Subject: OST Services (OSTS) Report No. PRELIMINARY
OST Services (OSTS) Job No. 499-12
Inspections of Piping Systems, Supports, and Restraints
Mitchell Generating Station Unit No. 1 Hot inspection January 2013

During January of 2013 a hot inspection was performed at Mitchell Generating Unit No. 1. The work included a walkdown of the critical piping systems along with their supports and restraints.

Figure No. 14
1-FWH-31 loose washer plate

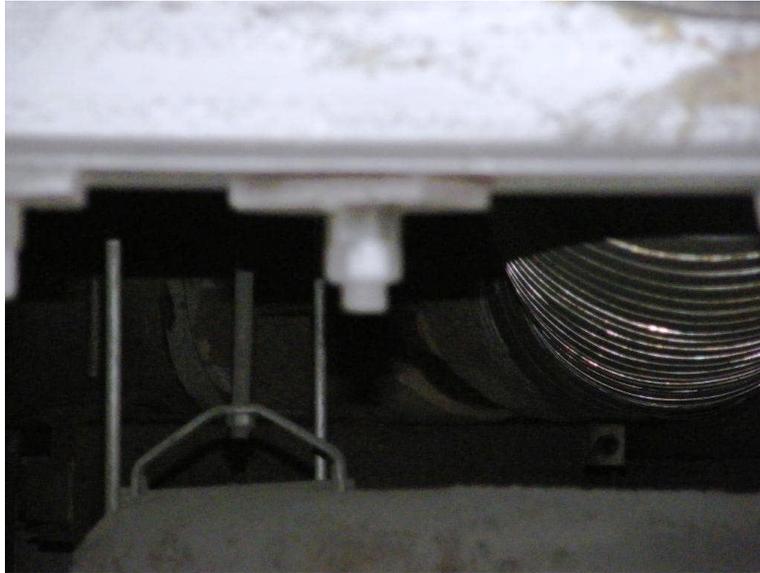
This trapeze assembly may have a loose U-bolt, due to a gap at the washer plate on the easternmost side of the U-bolt assembly (Figure No. 14). We recommend that this location be monitored for signs of unwanted lateral movement.

**Figure No. 17
MS SV config**

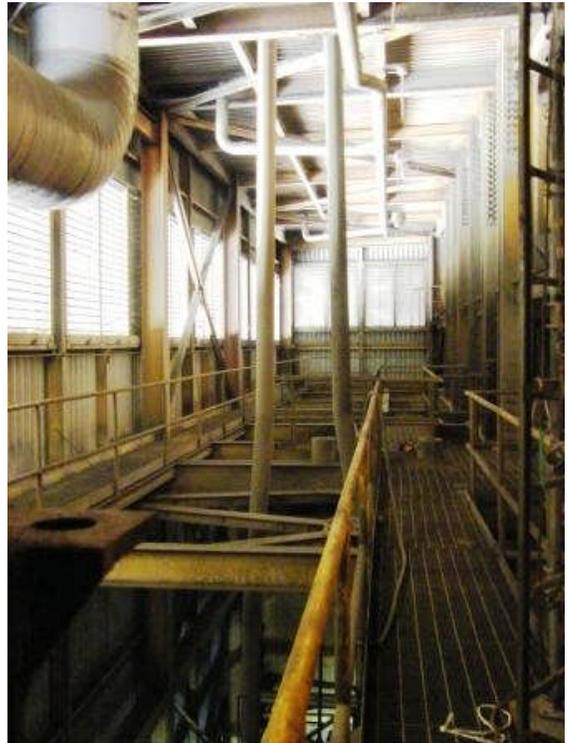
There are no visible supports on the discharge line to the roof penetration (Figure Nos. 17 and 18).

We recommend that the plant review the discharge piping system to ensure that the design is adequate when subjected to discharge conditions.

AEP MITCHELL - UNIT NO. 1
1st REHEAT STEAM SYSTEM
OSTS DWG.# MIT1-1RHBO REV. 0 1-5-09

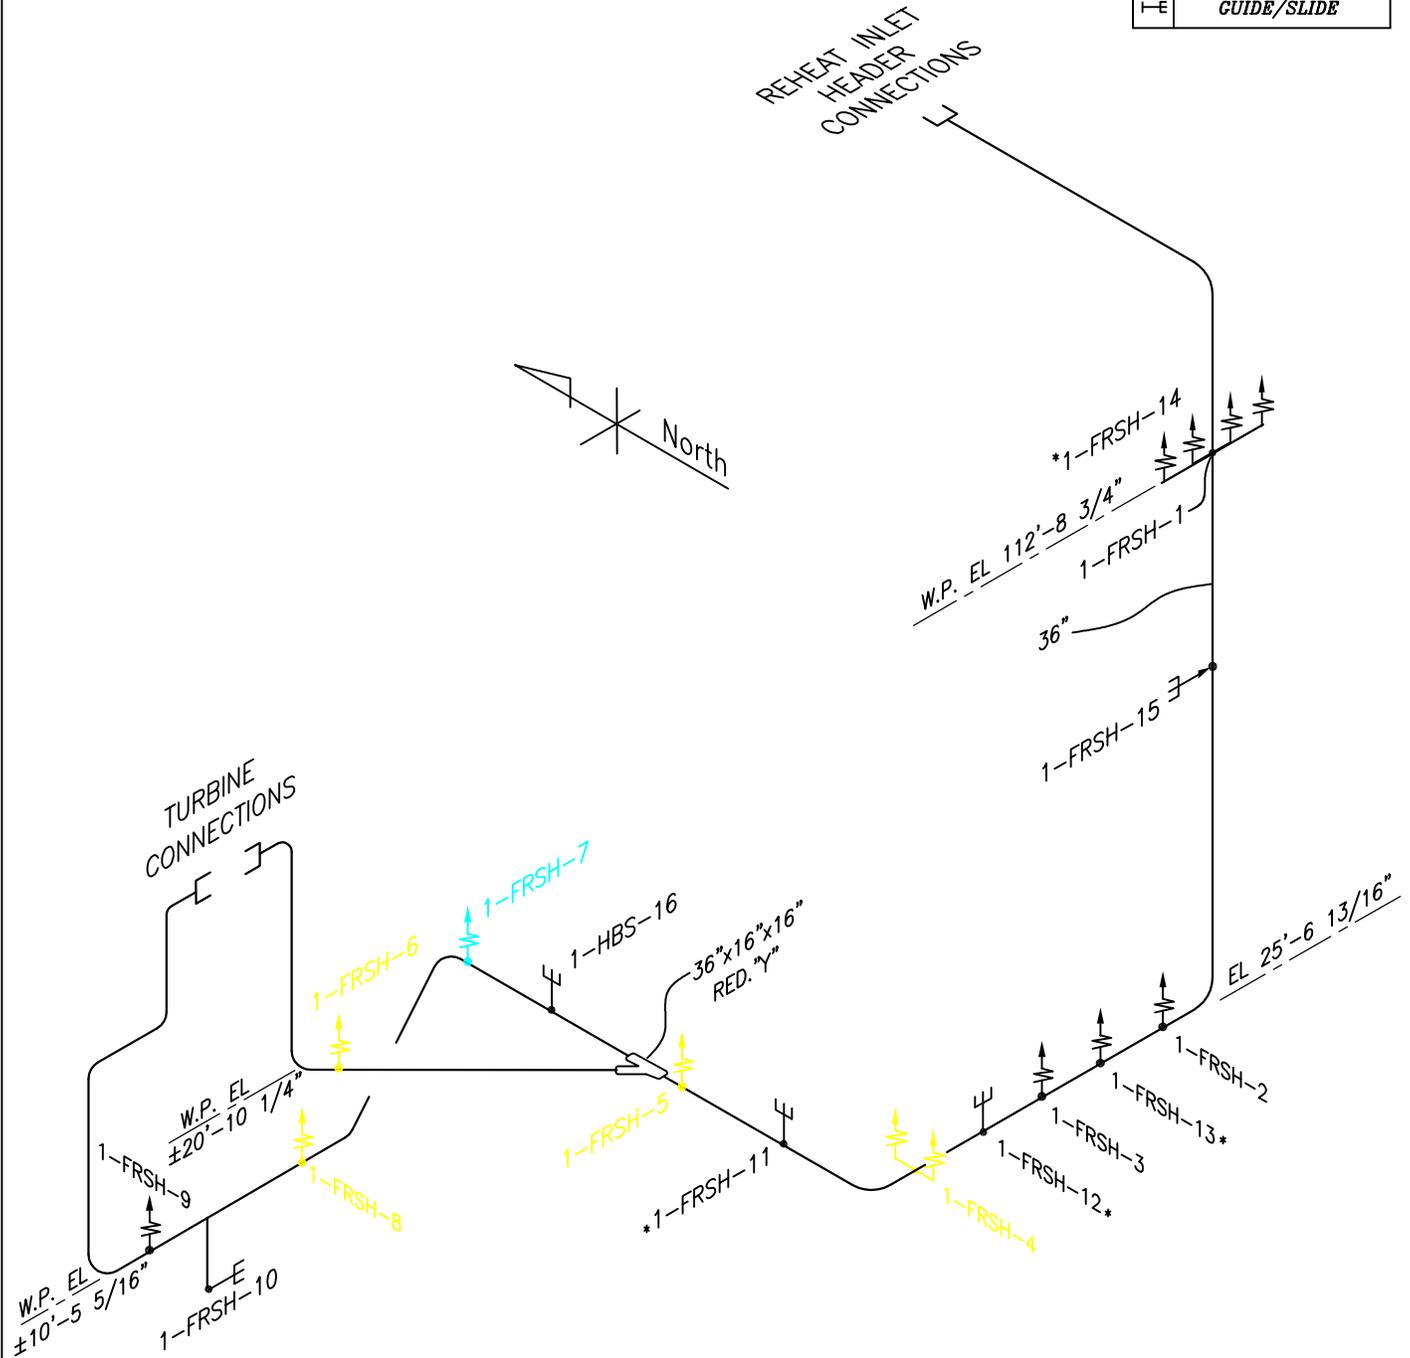
There are three constant support hangers along the bottom horizontal run of piping that are bottomed out in the hot condition. A fourth constant support, is supposed to be bottomed out in the hot condition, but is not. There are a number of factors to be considered and explored before contemplating any adjustments.

A marked up isometric of the bottomed out supports is also included.

This constant support trapeze assembly has a designed hot setting of 9.5. The northernmost spring was at 10.5 hot, and the southernmost spring was bottomed out in the hot condition.

This constant support has a designed hot setting of 7.0. The unit was bottomed out in the hot condition.

This constant support has a designed hot setting of 8.5. The unit was bottomed out in the hot condition.

This constant support assembly has a hot designed setting in the bottomed out position. The unit was at 4.0 in the hot condition. This is due to the bottomed out condition of FRSH-6.

First to be considered is the condition of the spring coils of the devices themselves. They could be at the end of their service lives and are no longer capable of supplying the rated loads. We recommend performing load testing on the affected supports during the next scheduled outage.

Second to be considered is the possibility of distortion present along this section of piping causing out of plane conditions. It would be advisable to rule this out while load testing was being performed. If distortion is suspected, it could have adverse consequences on line pitch, water collection and drainage, and ultimately lend itself to
